Pavement Preservation and Rehabilitation Program

2019 Overlays and Curb Ramps Project

Bid #3080

Addendum #2

Drawing No.
DT2

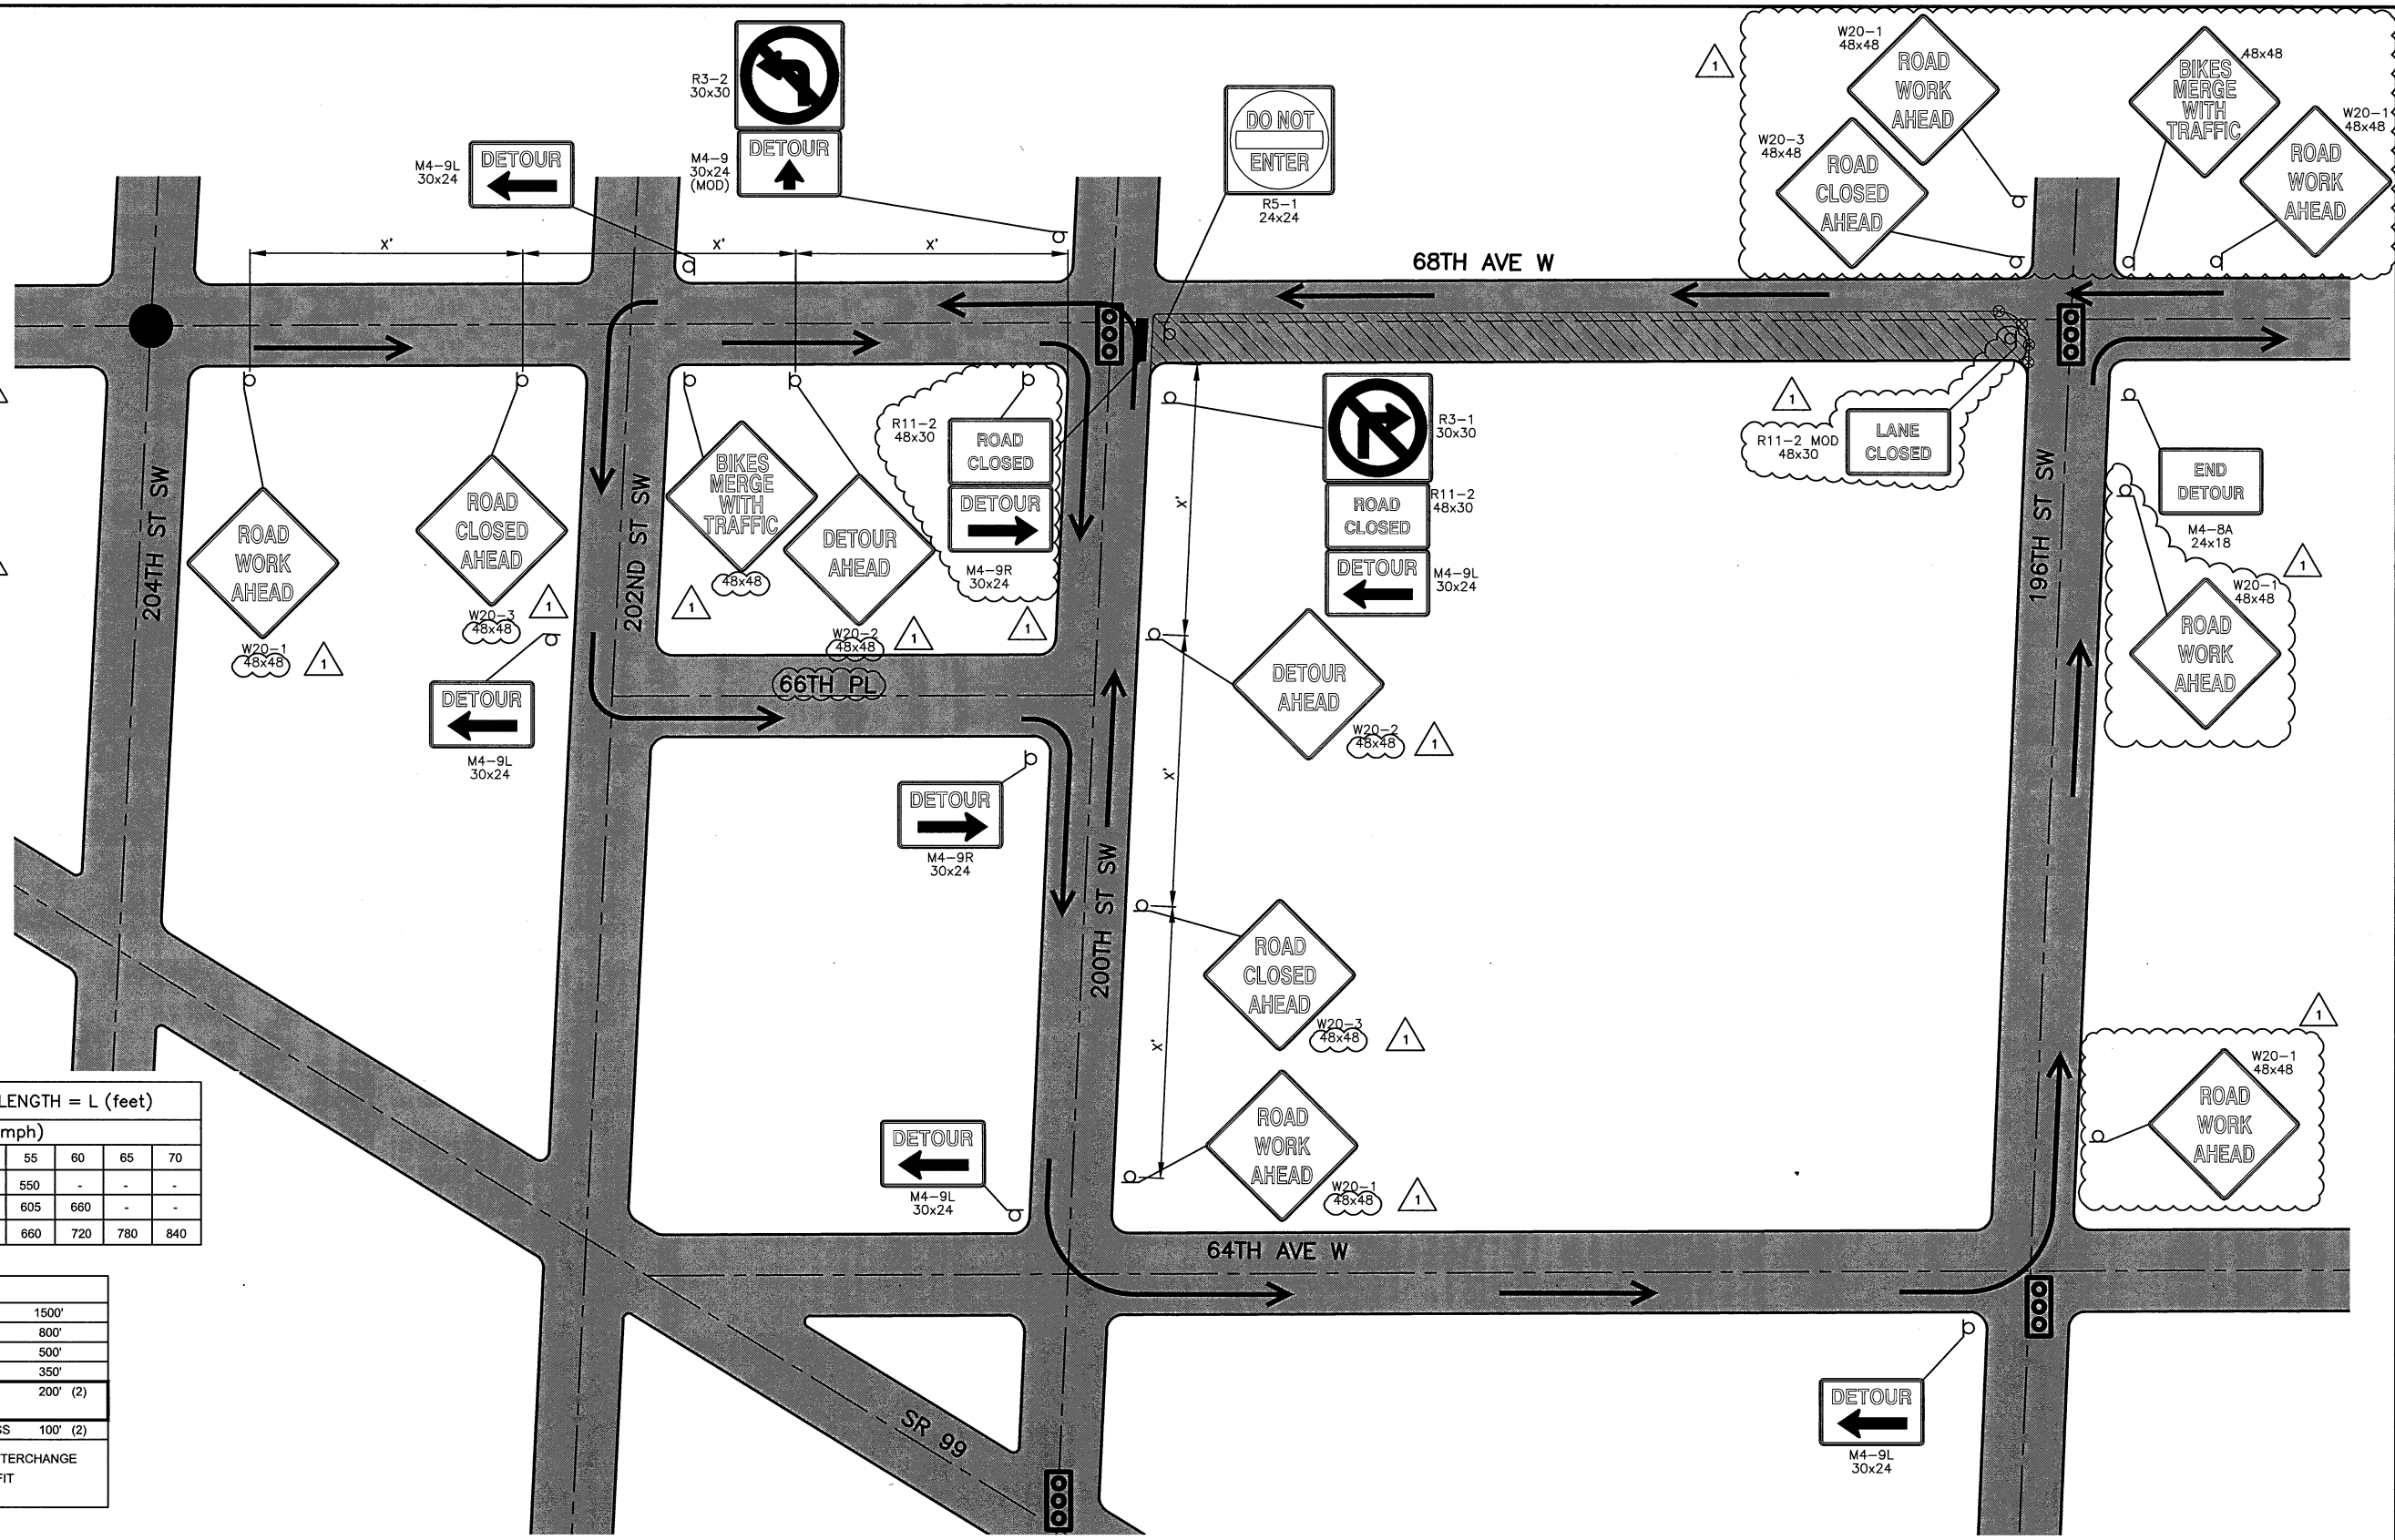
- A. Sheets 41-48 (Drawing Nos. DT1-DT8) – Detour Plans
- Replace in its entirety with the revised sheets, sheets 41-48, which are included as attachments to this addendum.
- B. Sheets 49-53 (Drawing Nos. TC1-TC5) – Traffic Control Plans and Details
- Replace in its entirety with the revised sheets, sheets 49-53, which are included as attachments to this addendum.
- C. Drawing No. CRD5 – Curb Ramp Details
- Drawing No. CRD5 has been added to the Plans to provide additional curb ramp information, pavement removal information, and additional drainage item installation information, which is included as an attachment to this addendum.

Drawing No.
CRD5
 Sheet No.
 of Total

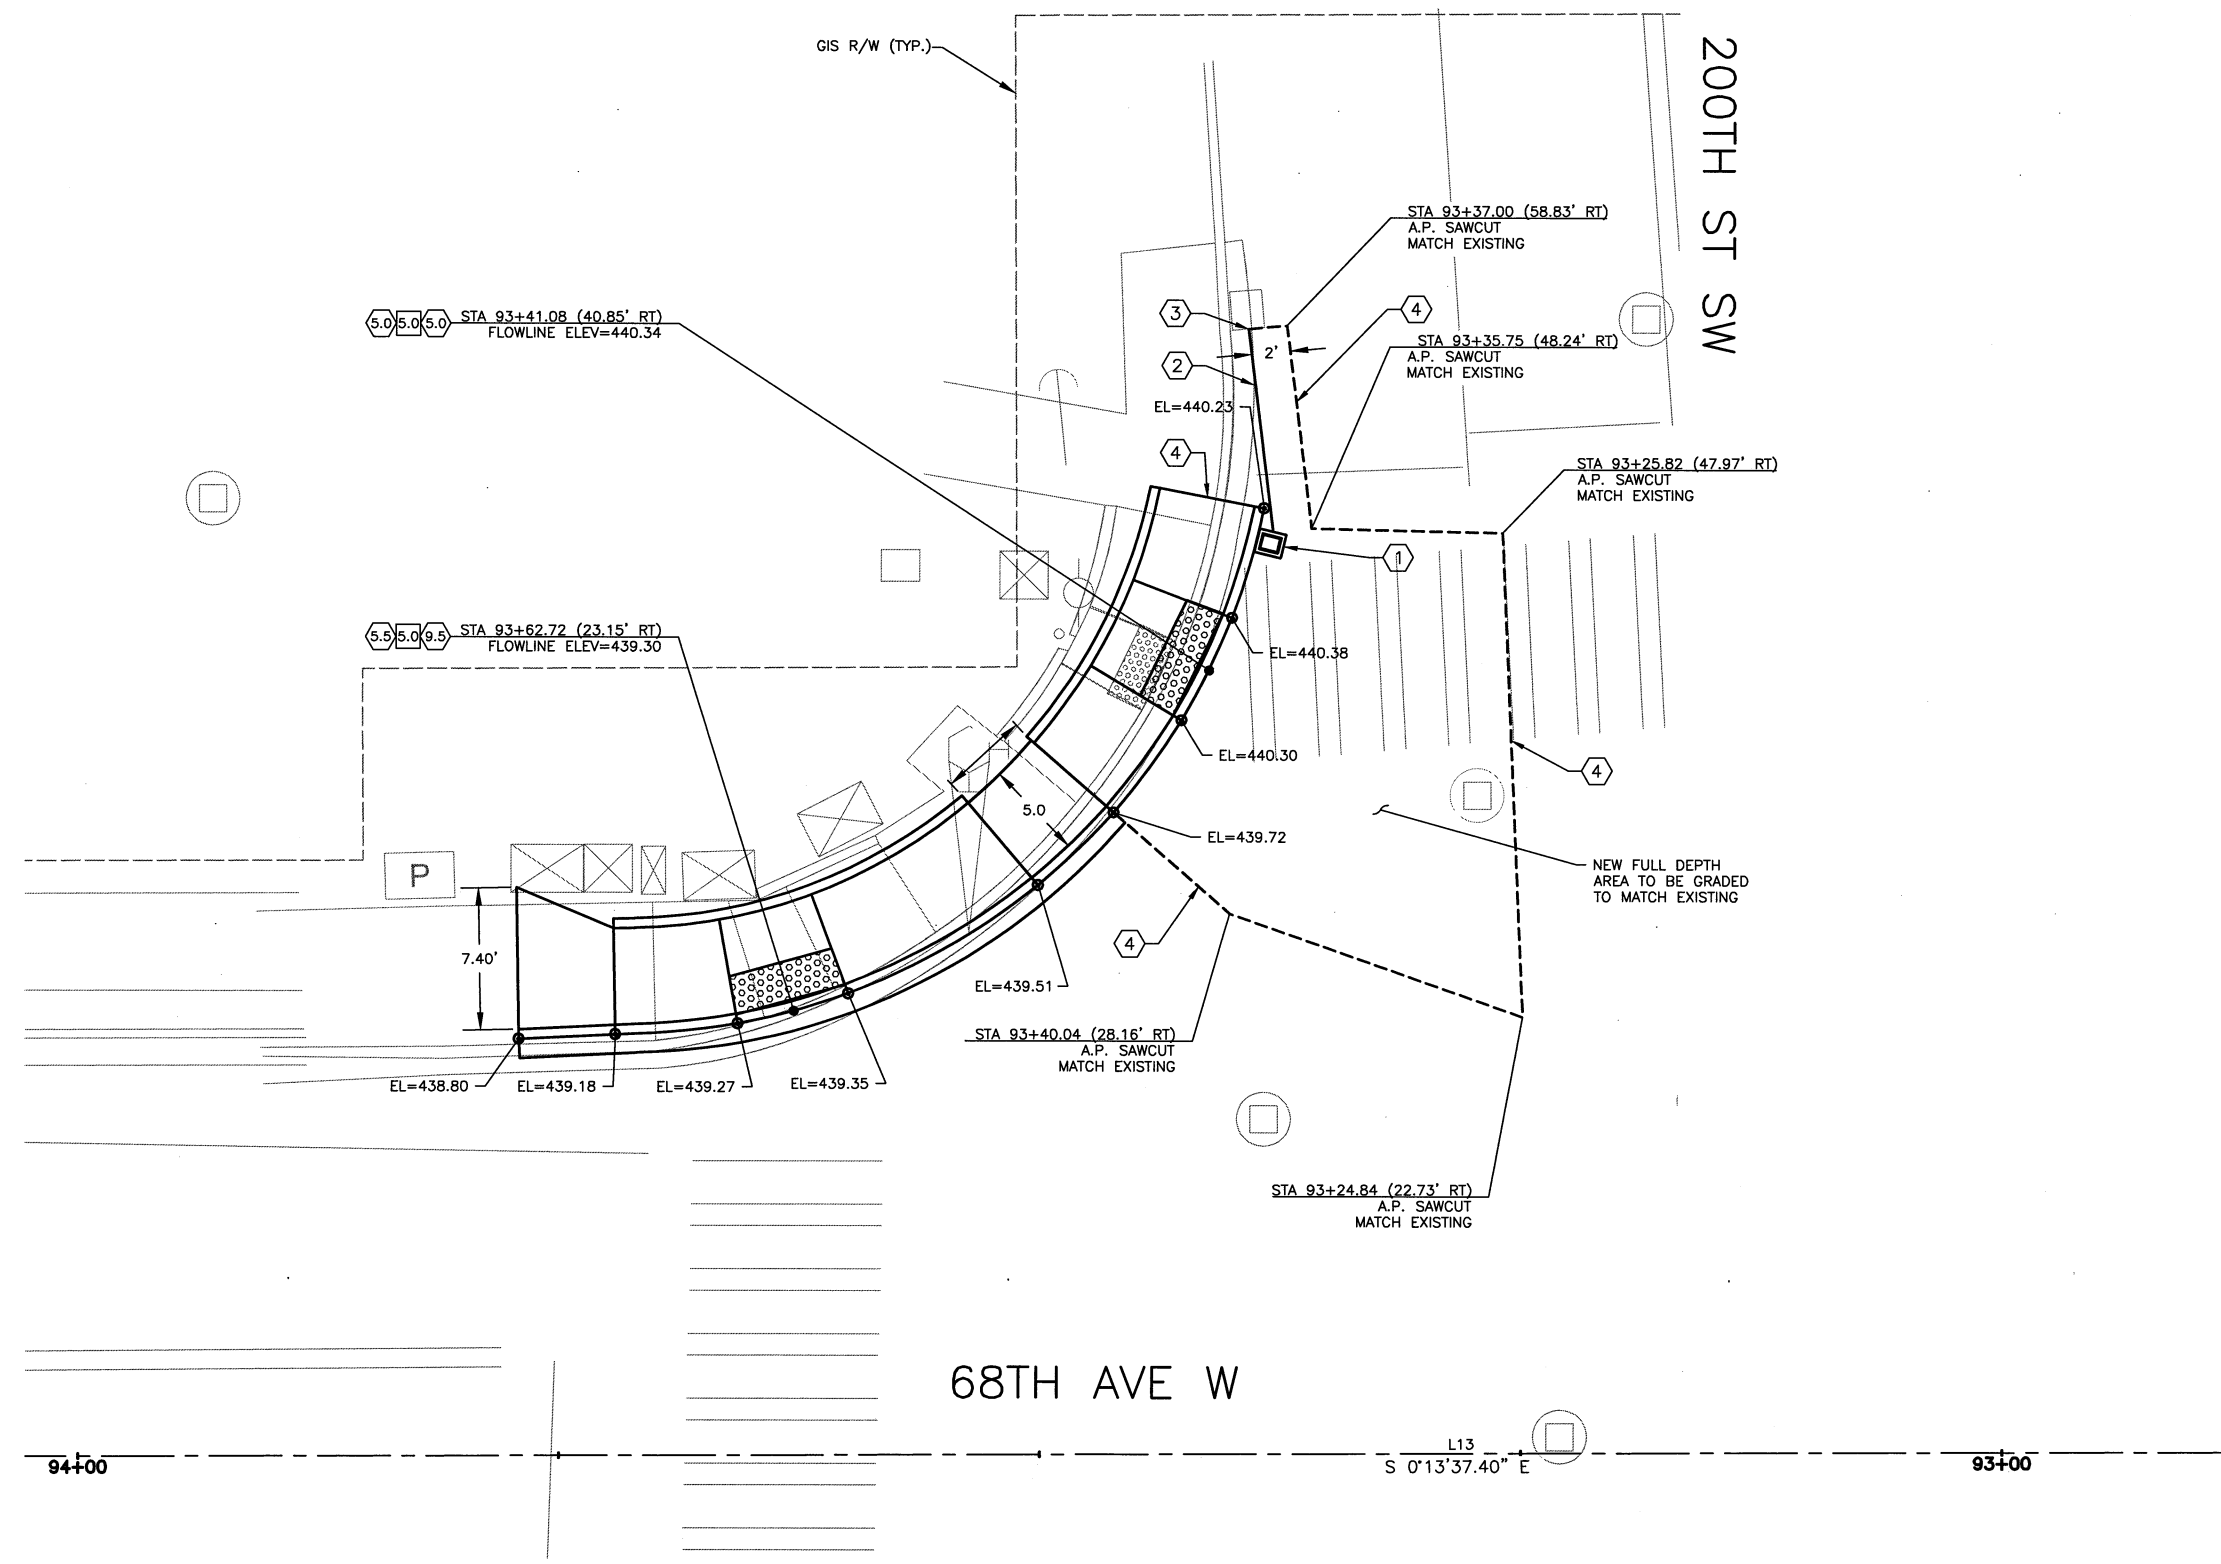
Add Plans Drawing No. CRD5

- ① INSTALL CONCRETE INLET PER WSDOT STD. PLAN B-25.60-02. STATION AND OFFSET TO BE VERIFIED IN THE FIELD BY THE ENGINEER.
- ② INSTALL 12 LF OF SCHEDULE A STORM SEWER PIPE 12 IN. DIAM.
- ③ CONNECT NEW STORM SEWER PIPE TO EXISTING DRAINAGE STRUCTURE.
- ④ SAWCUT.
